Attachment 3
Revision to the TS Bases Markups for
TS 3.2.1B and TS 3.2.1C
that were transmitted via OG-16-273 and OG-18-35
(Non-Proprietary)
(37 pages including Attachment 3 cover page)

Technical Specification Bases 3.2.1B
Heat Flux Hot Channel Factor Markups

B 3.2.1B Heat Flux Hot Channel Factor ($F_Q(Z)$) (RAOC-W(Z) Methodology)

B 3.2.1C Heat Flux Hot Channel Factor ($F_Q(Z)$) (CAOC-W(Z) Methodology)

Figure B 3.2.1B-1 (page 1 of 1)
 $K(Z)$ - Normalized $F_0(Z)$ as a Function of Core Height

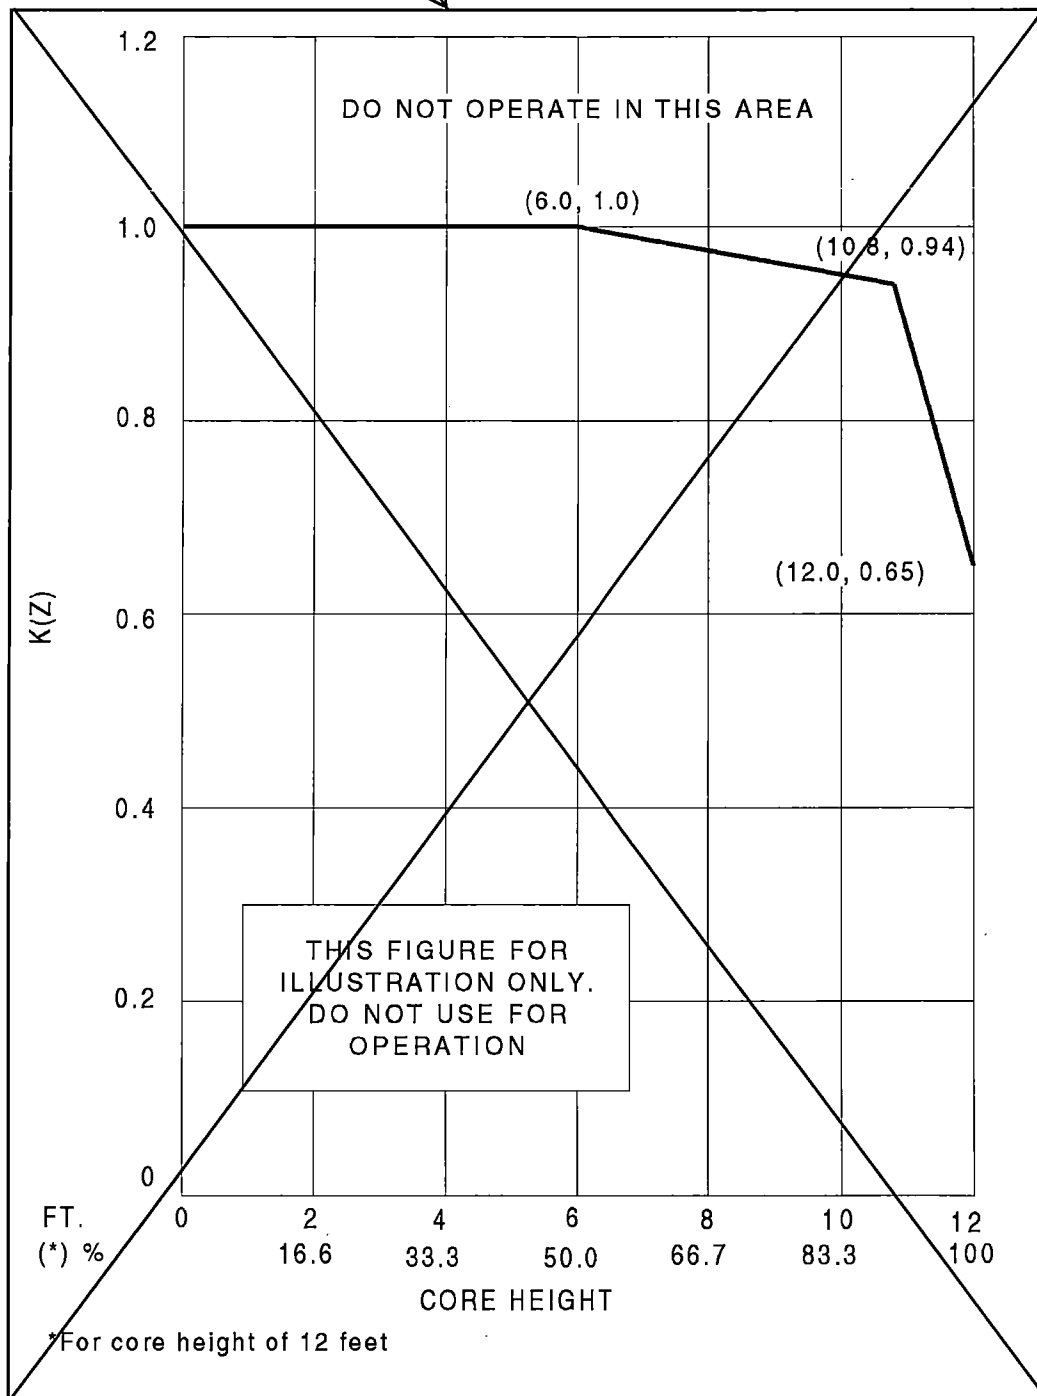
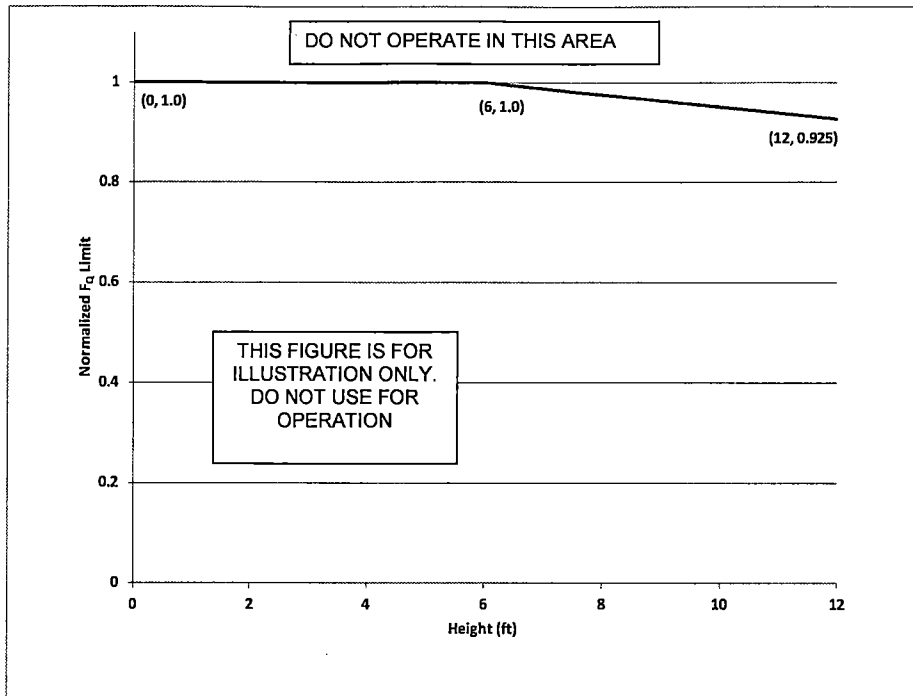
For this facility, the actual values of CFQ and $K(Z)$ are given in the COLR; however, CFQ is normally a number on the order of [2.32], and $K(Z)$ is a function that looks like the one provided in Figure B 3.2.1B-1.

Insert new Figure
(Next Page)

Figure B 3.2.1C-1 (page 1 of 1)
 $K(Z)$ - Normalized $F_Q(Z)$ as a Function of Core Height

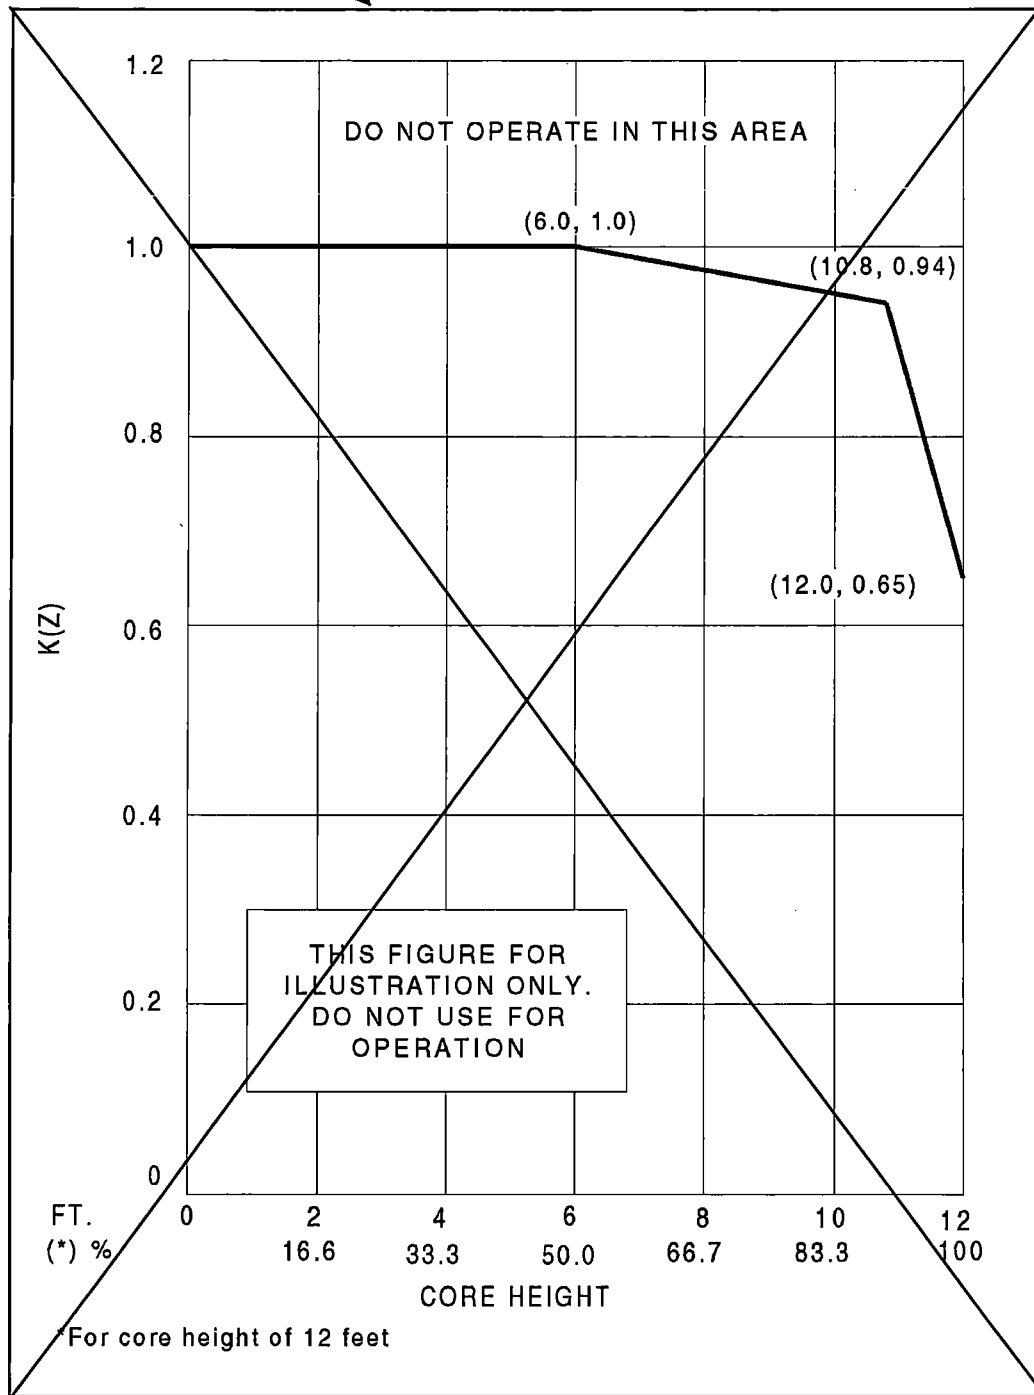
For this facility, the actual values of CFQ and $K(Z)$ are given in the COLR; however, CFQ is normally a number on the order of [2.32], and $K(Z)$ is a function that looks like the one provided in Figure B 3.2.1C-1.

Insert new Figure
(Next Page)
